Drain-Improvement: SPRINGMILL VILLAGES GRAAN - THE CROSSINGS - SECTION 18

## Springmill Villages Drain – The Crossings - Section 1

RE: Springmill Villages Drain-The Crossing Section 1B Arm

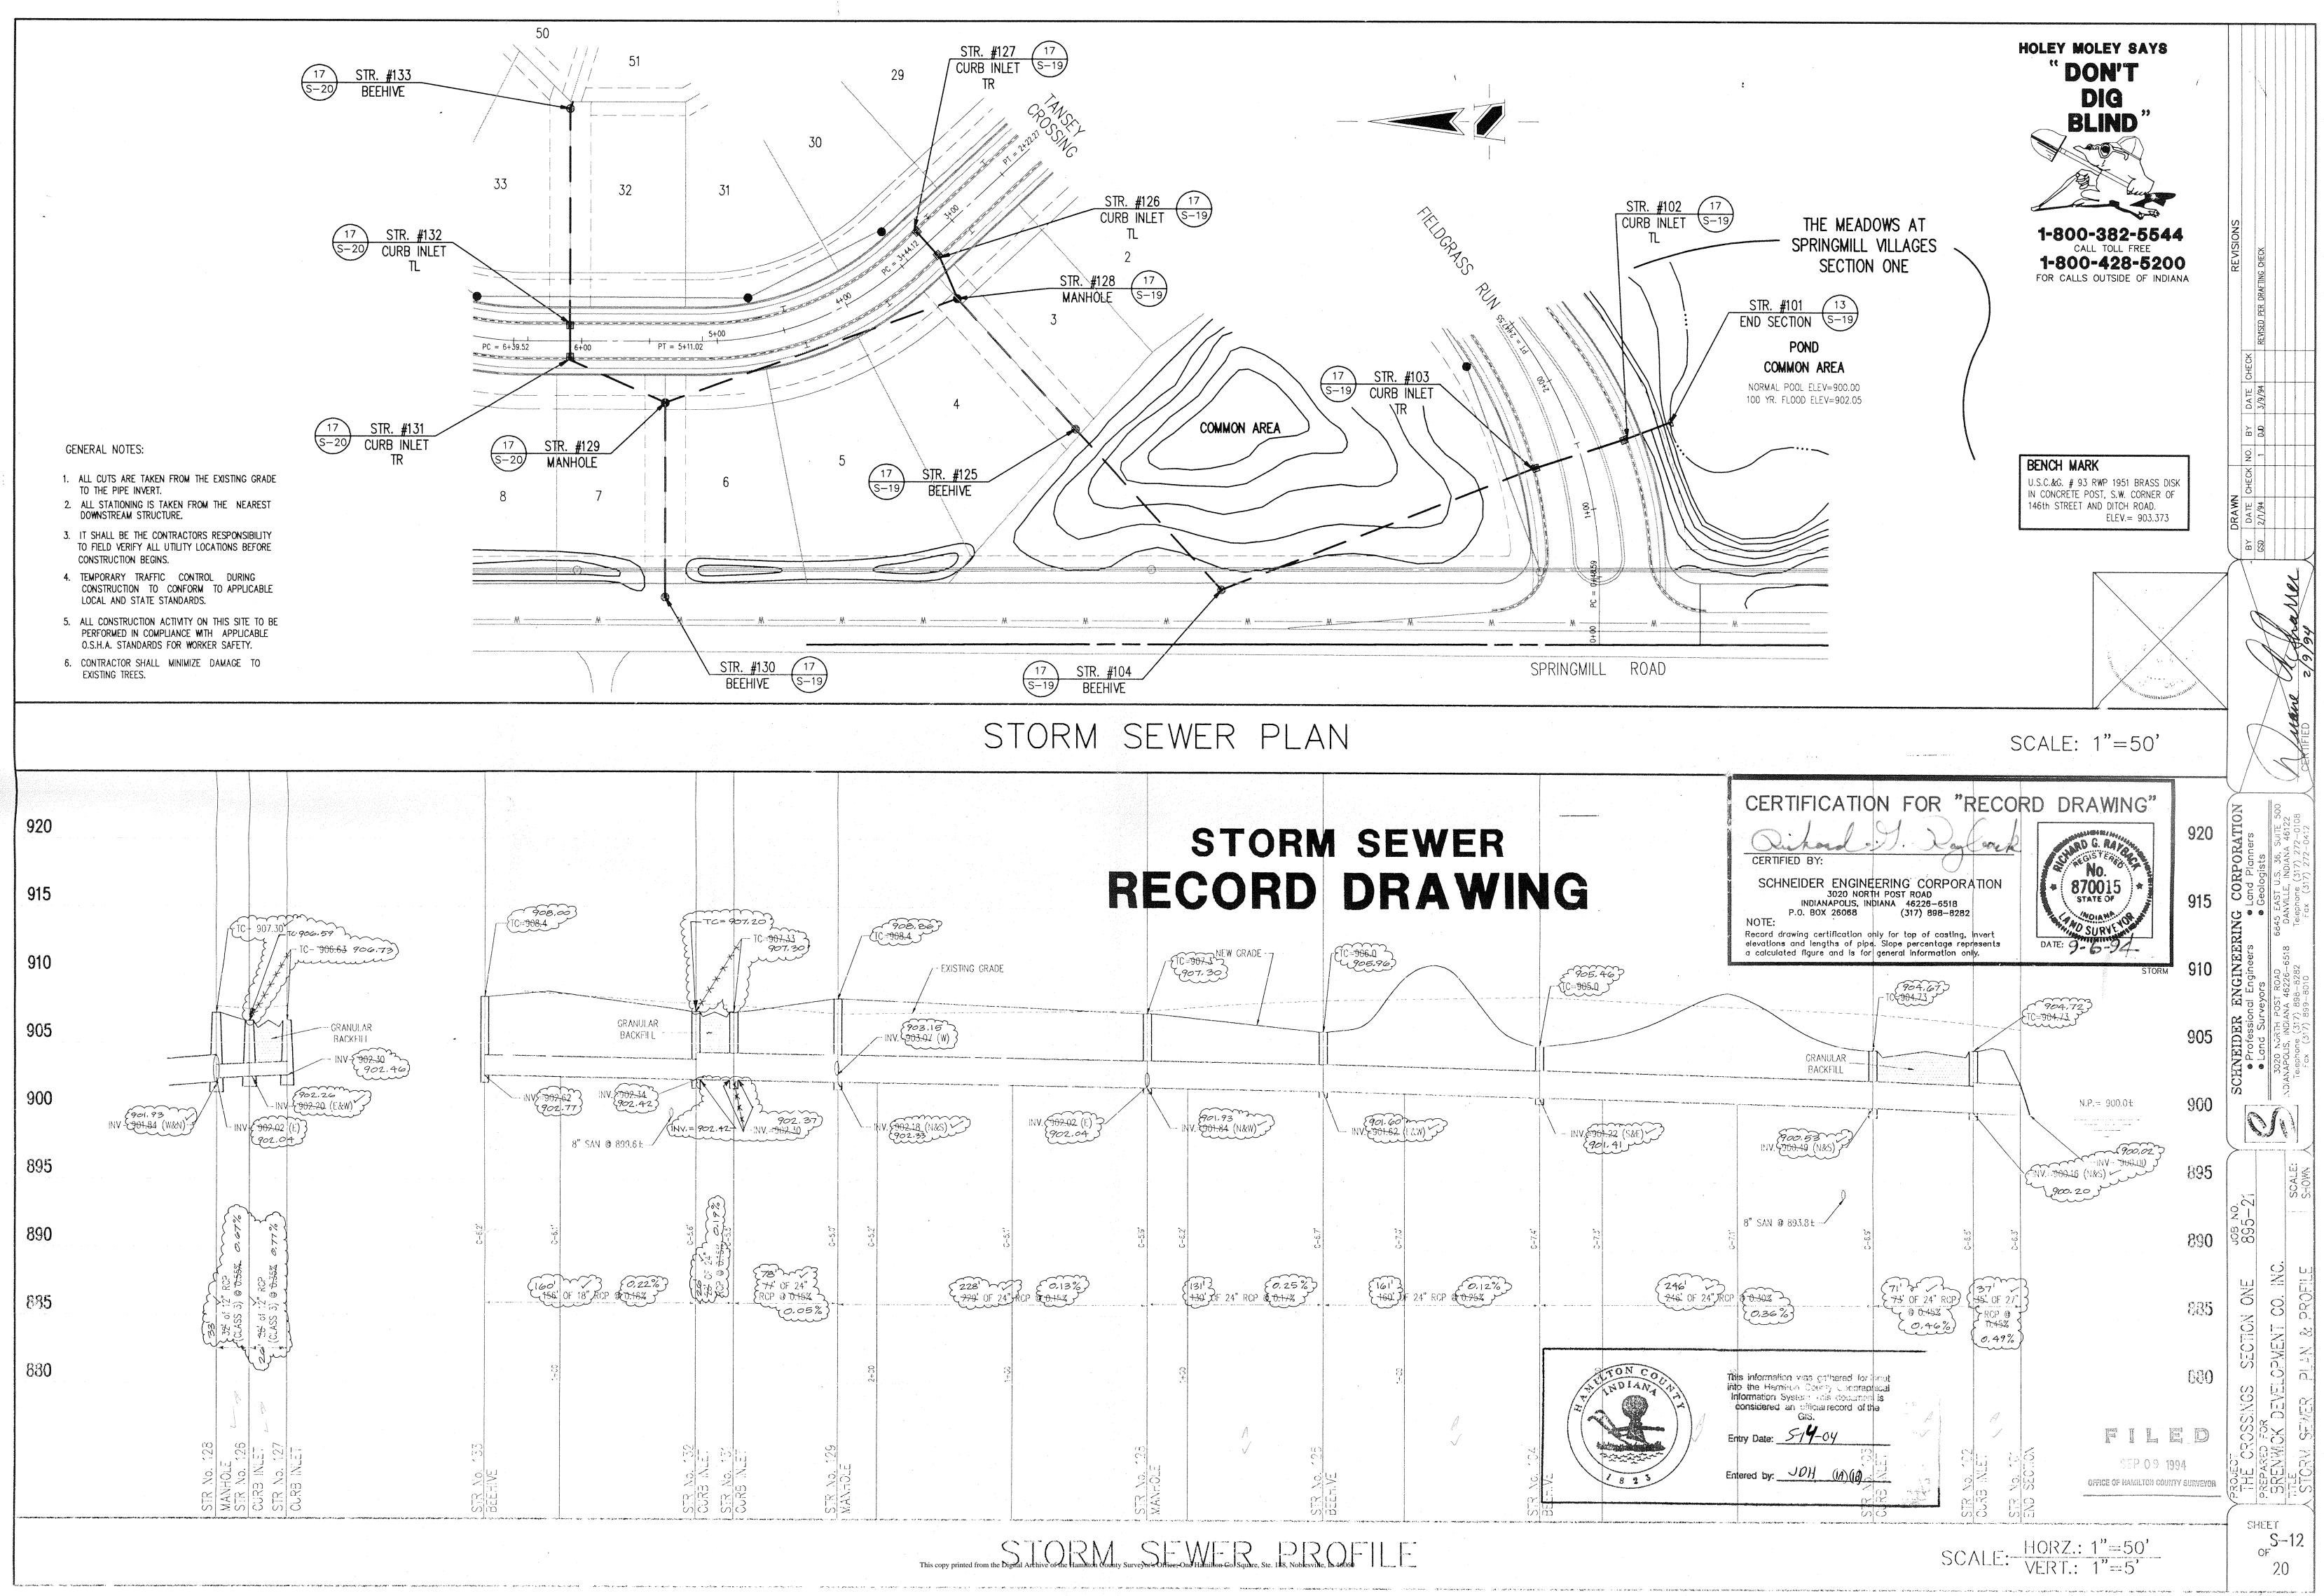
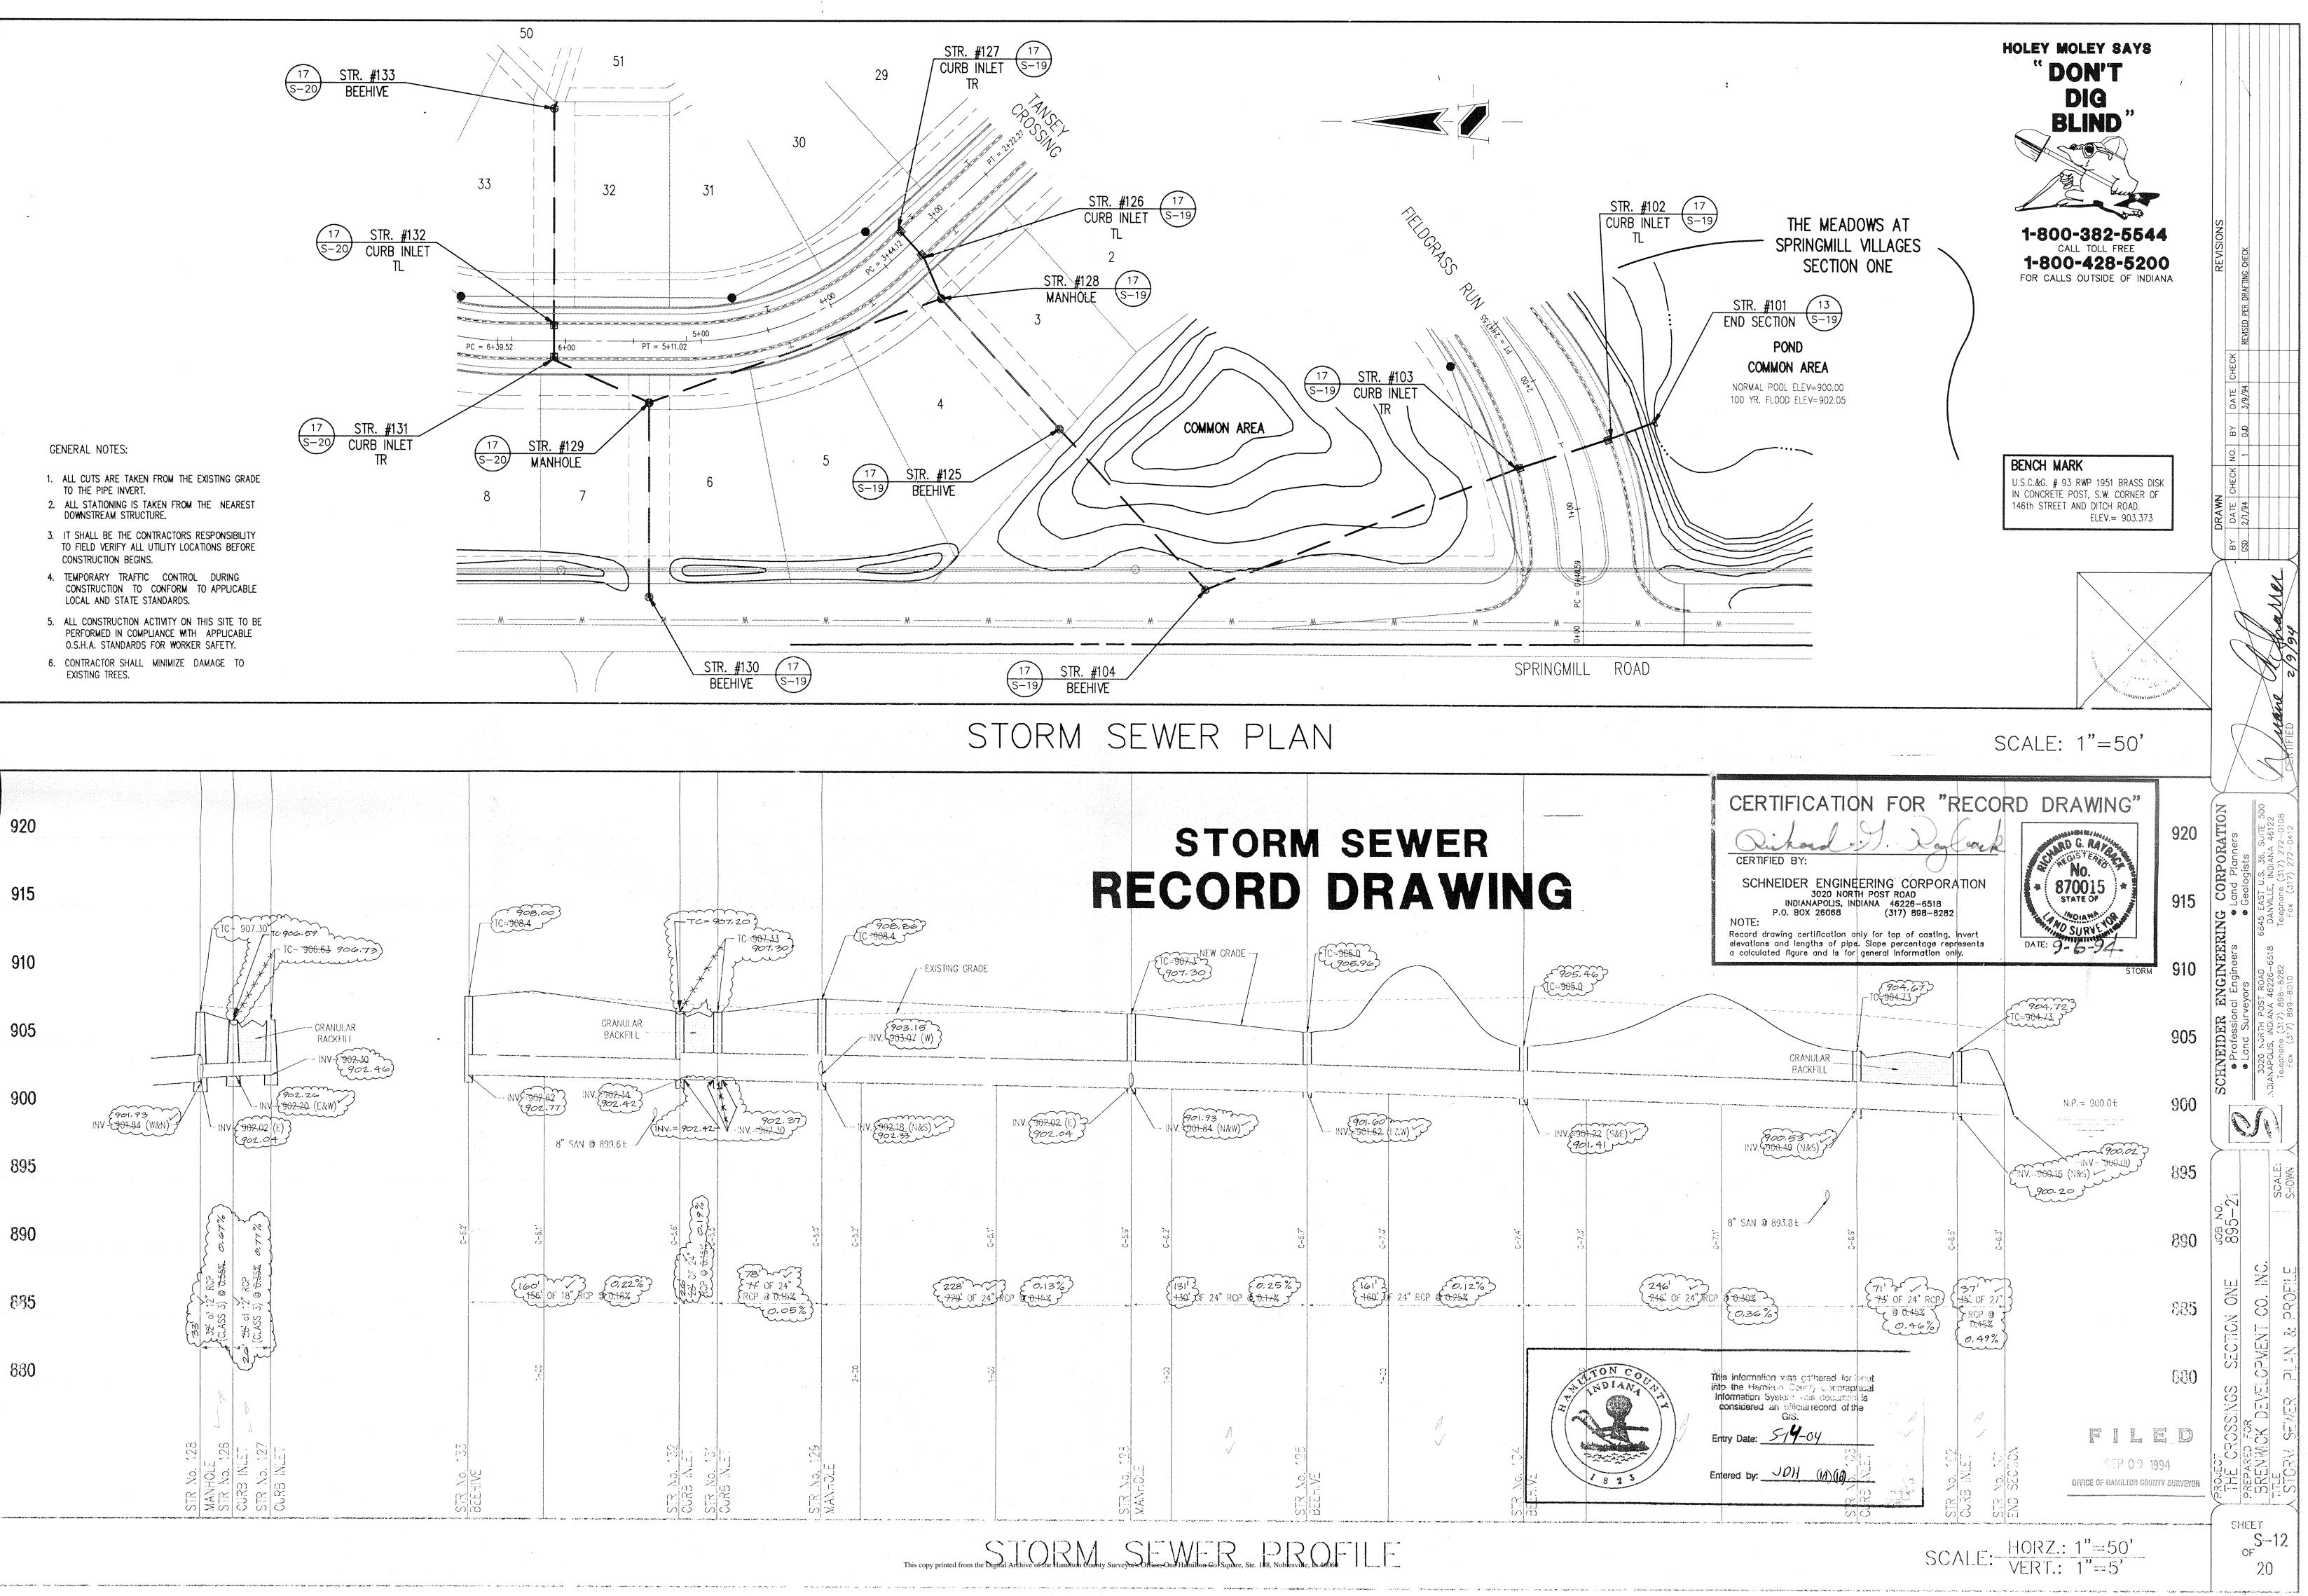
During construction, changes were made to the drain which will alter the plans submitted with my report for this drain dated December: 27, 1994. The changes are as followed:

229 228
STR 131 to 132 24" RCP shortened from 28' to 26 feet STR 132 to 133 18" RCP lengthened from 156' to 160 feet STR 129 to 130 12" RCP lengthened from 143' to 144 feet STR 138 to 137 12" RCP shortened from 28 to 26 feet STR 137 to 136 12" RCP shortened from 178' to 177 feet STR 136 to 139 12" RCP lengthened from 430' to 433 feet STR 139 to 140 12" RCP lengthened from 200 to 203 feet STR 148 to 145 12" RCP shortened from 43' to 41 feet	STR 128 to 129	129 24" RCP	shortened from	149' to 148 feet
STR 132 to 133 18" RCP lengthened from 156' to 160 feet STR 129 to 130 12" RCP lengthened from 143' to 144 feet STR 138 to 137 12" RCP shortened from 28 to 26 feet STR 137 to 136 12" RCP shortened from 178' to 177 feet STR 136 to 139 12" RCP lengthened from 430' to 433 feet STR 139 to 140 12" RCP lengthened from 200 to 203 feet STR 148 to 145 12" RCP shortened from 43' to 41 feet			lengthened from	77' to  78 feet

STR 129 to 130 12" RCP lengthened from 143' to 144 feet STR 138 to 137 12" RCP shortened from 28 to 26 feet STR 137 to 136 12" RCP shortened from 178' to 177 feet STR 136 to 139 12" RCP lengthened from 430' to 433 feet STR 139 to 140 12" RCP lengthened from 200 to 203 feet STR 148 to 145 12" RCP shortened from 43' to 41 feet	STR 131 to 132		shortened from	28' to 26 feet
STR 138 to 137 12" RCP shortened from 28 to 26 feet STR 137 to 136 12" RCP shortened from 178' to 177 feet STR 136 to 139 12" RCP lengthened from 430' to 433 feet STR 139 to 140 12" RCP lengthened from 200 to 203 feet STR 148 to 145 12" RCP shortened from 43' to 41 feet			lengthened from	156' to 160 feet
STR 137 to 136 12" RCP shortened from 178' to 177 feet STR 136 to 139 12" RCP lengthened from 430' to 433 feet STR 139 to 140 12" RCP lengthened from 200 to 203 feet STR 148 to 145 12" RCP shortened from 43' to 41 feet			lengthened from	143' to 144 feet $\sim$

STR 136 to 139 12" RCP lengthened from 430' to 433 feet STR 139 to 140 12" RCP lengthened from 200 to 203 feet STR 148 to 145 12" RCP shortened from 43' to 41 feet	STR 138 to 137	137 12" RCP	shortened from	28 to 26 feet $\checkmark$
STR 139 to 140 12" RCP lengthened from 200 to 203 feet STR 148 to 145 12" RCP shortened from 43' to 41 feet	STR 137 to 136	136 12" RCP	shortened from	178' to 177 feet
STR 148 to 145 12" RCP shortened from 43' to 41 feet	STR 136 to 139	139 12" RCP	lengthened from	430' to 433 feet 🖉
	STR 139 to 140	140 12" RCP	lengthened from	200 to 203 feet $\sim$
COND 147 to 146 108 DOD chembered from 401 to 40 fact /	STR 148 to 145	145 12" RCP	shortened from	43' to 41 feet
SIR 147 to 140 12" RCP SNORTENED IROM 42' to 40 feet	STR 147 to 146	146 12" RCP	shortened from	42' to 40 feet
STR 146 to 145 12" RCP shortened from 43' to 40 feet $\checkmark$	STR 146 to 145		shortened from	43' to 40 feet $ee$

STR 145 to 144	144 12" RCP	shortened from	
STR 144 to 143 12" RCP shortened from 178' to 177 feet $\checkmark$	STR 144 to 143	143 12" RCP	shortened from	
STR 141 to 142 12" RCP shortened from 142' to 138 feet $\checkmark$	STR 141 to 142	142 12" RCP	shortened from	142' to 138 feet 🗸
STR 143 to 149 12' RCP shortened from 28' to 26 feet $\checkmark$	STR 143 to 149		shortened from	
STR 149 to 150 12" RCP lengthened from 207' to 209 feet	STR 149 to 150	150 12" RCP	lengthened from	207' to 209 feet
STR 151 to 157 24" RCP lengthened from 172' to 173 feet	STR 151 to 157	157 24" RCP	lengthened from	
STR 157 to 158 21" RCP lengthened from 297' to 298 feet			lengthened from	
STR 158 to 159 21" RCP shortened from 88' to 86 feet			shortened from	
STR 159 to 160 21" RCP lengthened from 157' to 158 feet	STR 159 to 160		lengthened from	
STR 160 to 161 15" RCP lengthened from 380' to 383 feet	STR 160 to 161	161 15" RCP	lengthened from	380' to 383 feet

The corrected total of six (6") inch SSD is 4,981 feet

The length of the drain due to the changes described above is now 8,404 feet.
